# 3812 - Addendum 1

To	Kristen Haskell	Date	10/03/25
For	Long Creek Youth Development Center Ceiling Replacement	Project No.	BGS# 3812 SMRT# 25014

This addendum forms a part of the bidding and contract documents.

5 INTERIOR ELEVATION  
1/8" = 1'-0"

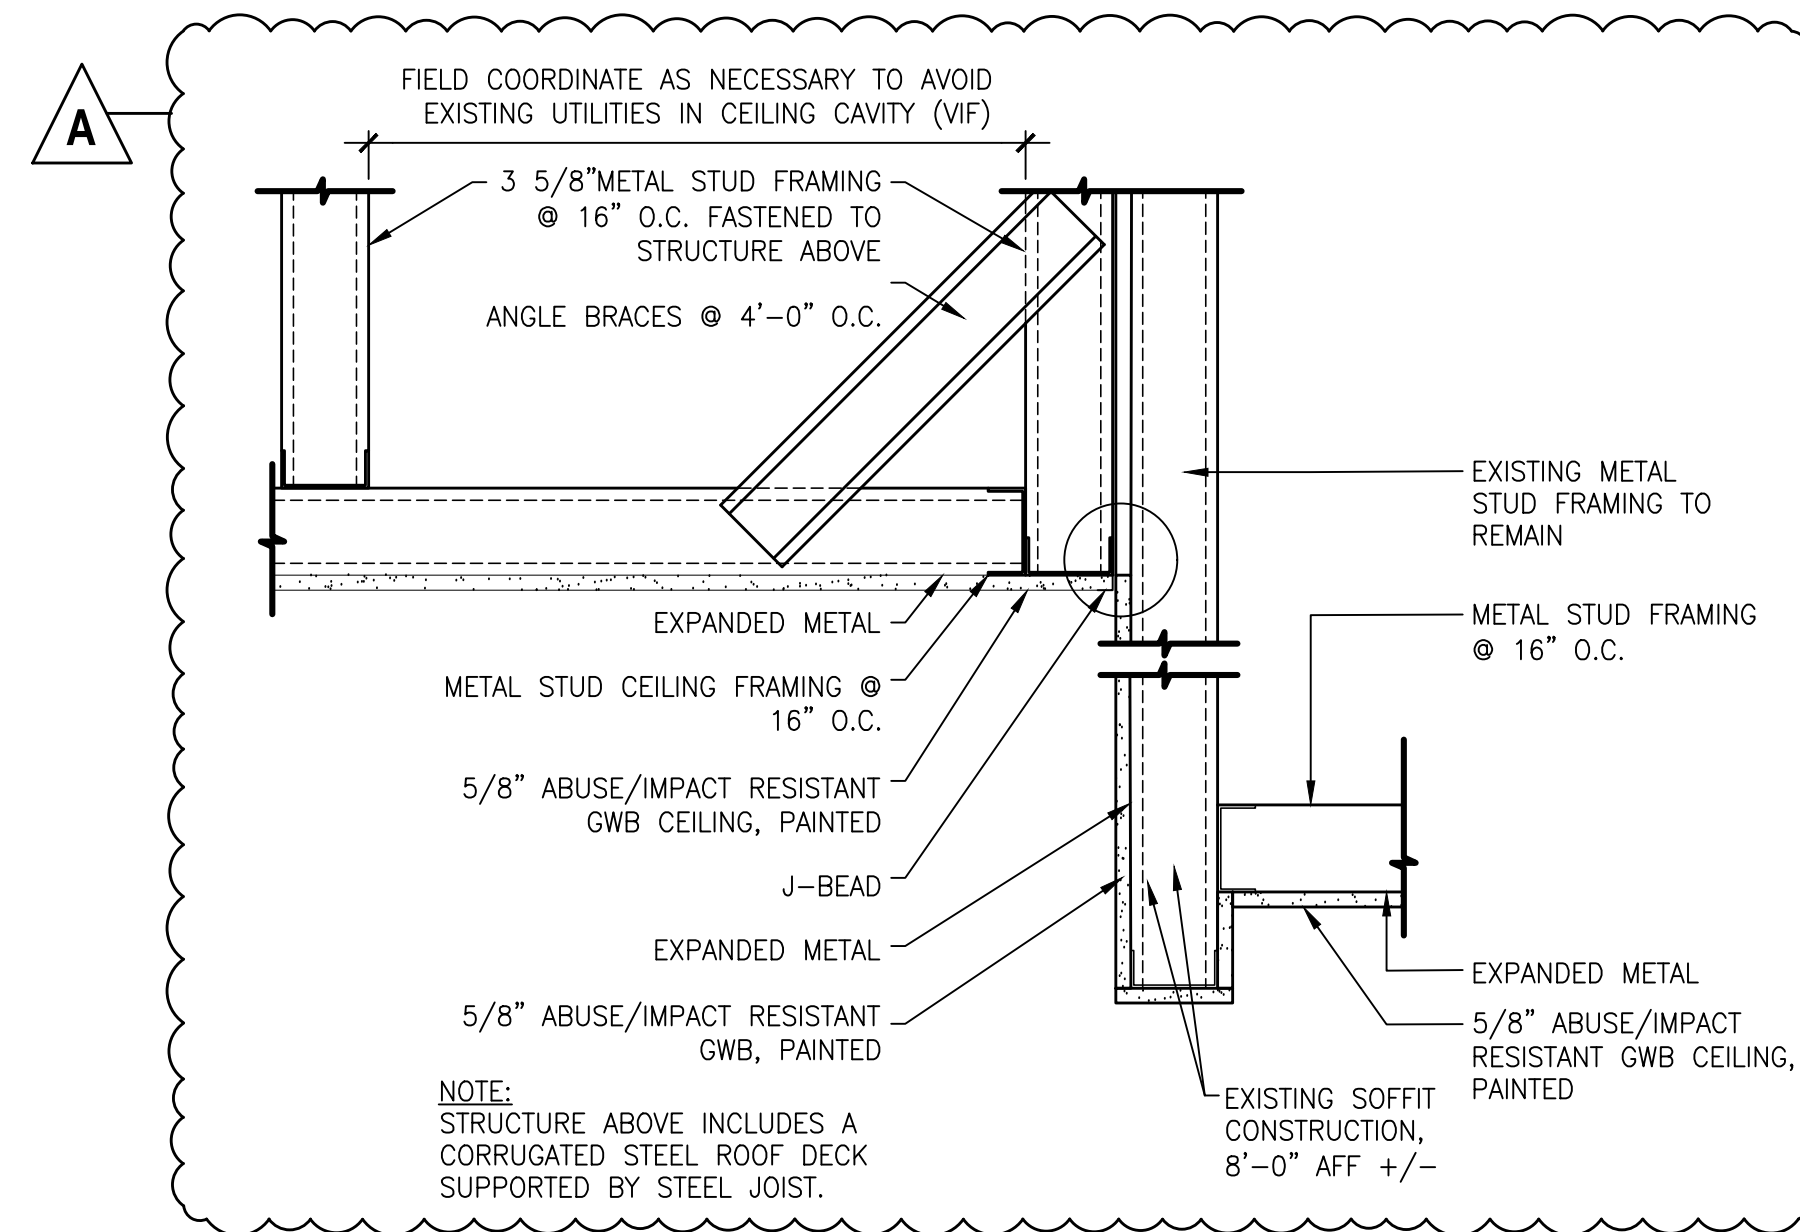
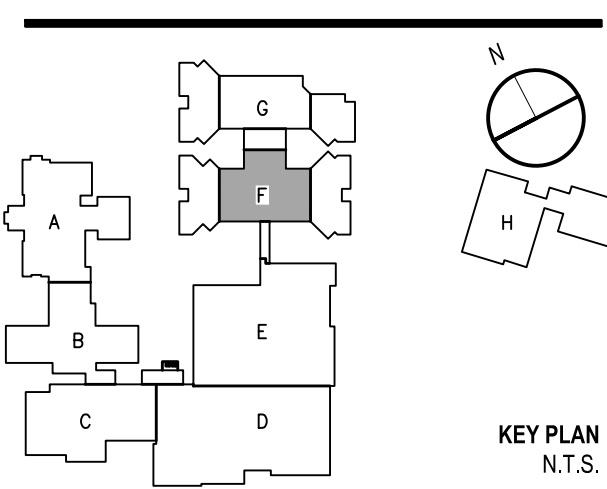
BIDDER QUESTIONS	
Q1.	Is the impact face is needed. There typically isn't a need for this type of face on the ceiling. RESPONSE: <b>Yes, the impact face is necessary.</b>
Q2.	AD102 existing pictures didn't come through on the plans? RESPONSE: <b>Refer to the attached revised drawing AD102 for photos.</b>
Q3.	Access panels are noted and mentioned to show minimum on plans? We don't see any shown. Is there a quantity we should carry with it being unknown? RESPONSE: <b>Provide (4) four security access panels within each housing unit, in addition to those called for on the reflected ceiling plans. Refer to added architectural note 10 on the attached revised drawing AE101 &amp; AE102.</b>

Q17.	For larger spans, please advise what the metal stud framing should be for the ceiling. Please provide a framing detail. RESPONSE: <b>Refer to specification section 092216 and the attached revised drawings AE101 &amp; AE102 for framing requirements.</b>
Q18.	Please advise what the metal stud framing for the new ceilings will be attached to and how it should be attached. Please provide a detail. RESPONSE: <b>Refer to specification section 092216 and the attached revised drawings AE101 &amp; AE102 for framing requirements.</b>
Q19.	What should be the finish height of the ceilings? RESPONSE: <b>Refer to the attached revised drawings AE101 &amp; AE102 for ceiling heights.</b>
Q20.	Please advise the height to the roof deck above the ceiling. RESPONSE: <b>Refer to architectural note 14 on the attached revised drawings AE101 and AE102 for bottom of steel roof deck height.</b>
Q21.	Are the walls in each room to be painted? If so, what paint and color? RESPONSE:

<b>No. Refer to the attached revised drawings AE101 &amp; AE102, and the attached revised specification section 099123 for paint scope clarifications.</b>
Q22.	Please confirm flooring is now included in this SOW. RESPONSE: <b>Flooring is not included in the scope of work. Any existing flooring damaged by construction activities would need to be replaced with new flooring.</b>
Q23.	Please advise what gauge metal studs should be installed. RESPONSE: <b>Refer to specification section 091116, 2.2, 1., a.</b>
Q24.	Please confirm no insulation is to be installed above the GWB ceilings. RESPONSE: <b>There's no insulation at the ceilings. Refer the drawings for required insulation locations.</b>
Q25.	Please advise who the existing fire alarm contractor is. RESPONSE: <b>Johnson Controls</b>
Q26.	Who services the existing fire suppression system? RESPONSE: <b>Johnson Controls</b>
Q27.	Can the superintendent be the SSHO & QCM? RESPONSE: <b>Yes.</b>
